Technical Memo

Subject: Software Release [V1.70]

Issue No.
HDCM24-024

Model Name / Model Family Name	Model Name / Model Family Name	Model Name / Model Family Name	Model Name / Model Family Name
RCP-3500	RCP-3501

2. Screen Saver function

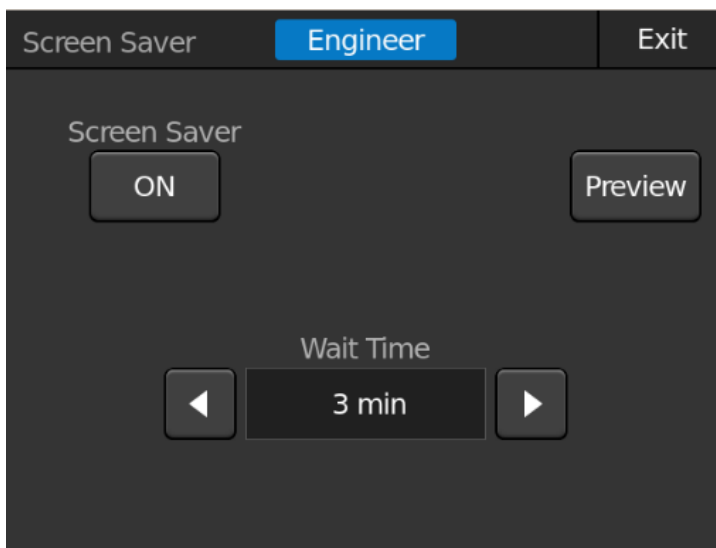
To protect the LCD, added a function to switch to a black screen after a certain period of inactivity. To deal with the problem of LCD burn-in and brightness reduction with RCP.

Added the “Config->RCP->Mode->Screen Saver” menu.

By turning on the Screen Saver, the Screen Saver would start if no operations related to the LCD display are performed for a certain period. While the Screen Saver is running, the screen will remain black, and nothing will be drawn on it. The Screen Saver can be canceled by touching the LCD.

3. CCU PinP RET input setting

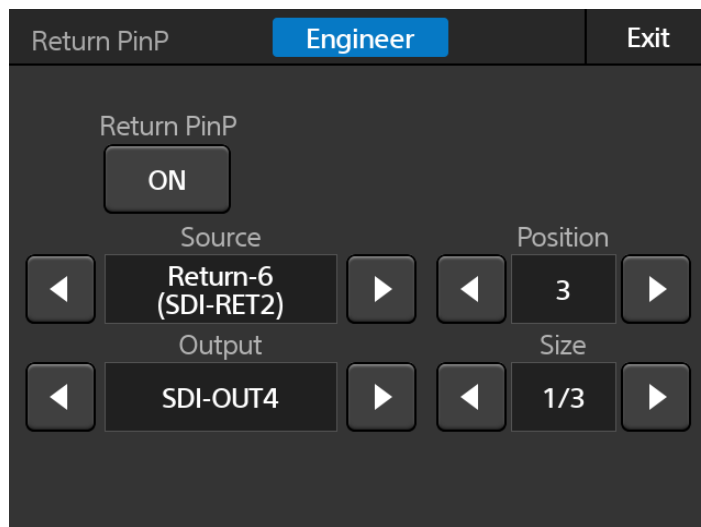
Added the “Config->CCU->Return PinP” menu. In this menu, it is enabled to set the CCU Return PinP function.

- RETURN PinP: Set the On/Off of Picture in Picture function
- OUTPUT: Set the output for displaying Picture In Picture from SDI-OUT3-4 and IP OUT1-2
- SOURCE: Set the video signal to be displayed on Picture In Picture from RETURN SELECT 1-8 and HD PROMPTER
- POSITION: Set the location where Picture In Picture is displayed (1-4)
- SIZE: Set the Picture In Picture size to 1/4, 1/3, or 1/2.5

Switch assignment label: Old and New Comparison

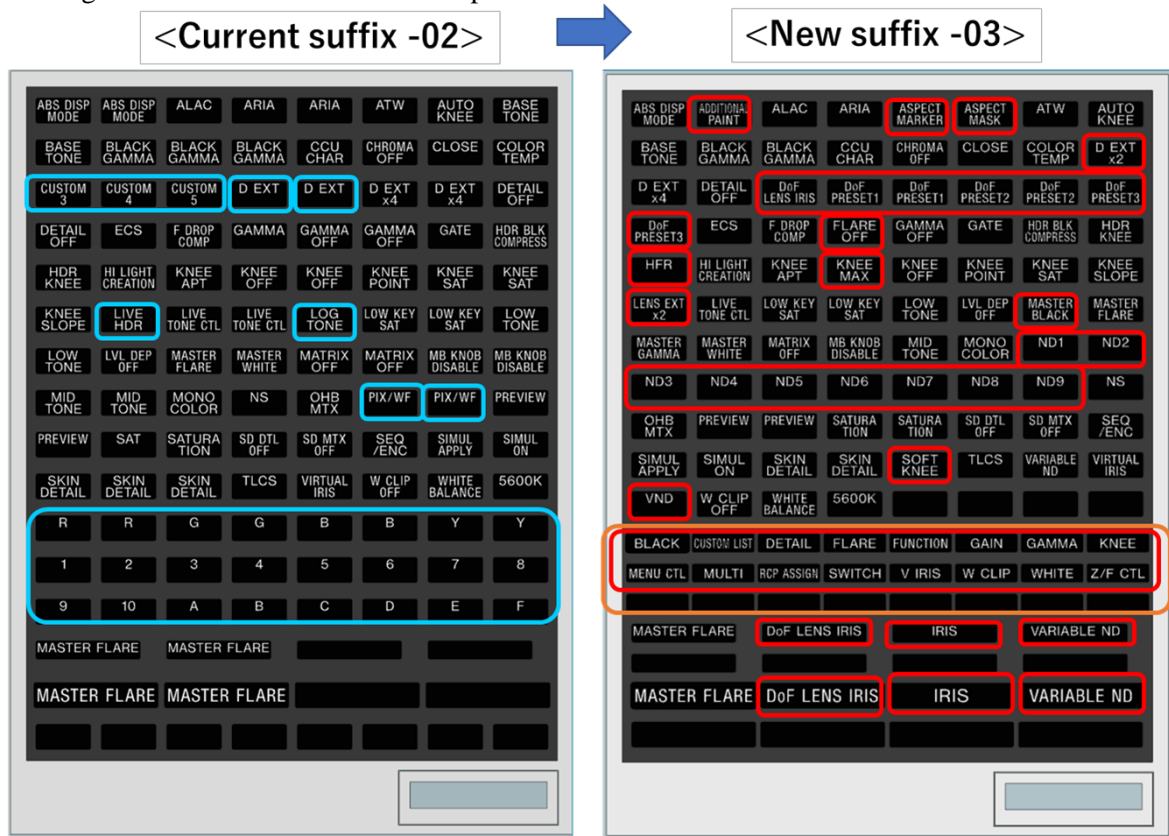
The switch assignment label included with the product has been changed. Please order a new part (suffix -03) if necessary.

Function names have been added to the SW/knob assignment items (by adding new functions and improving the operability of existing functions), and the label type and size have been changed.

Changed the label of the function name

The number of labels with the same function name has changed
Adding a new size label

Number: 5-016-159-02 ⇒ -03
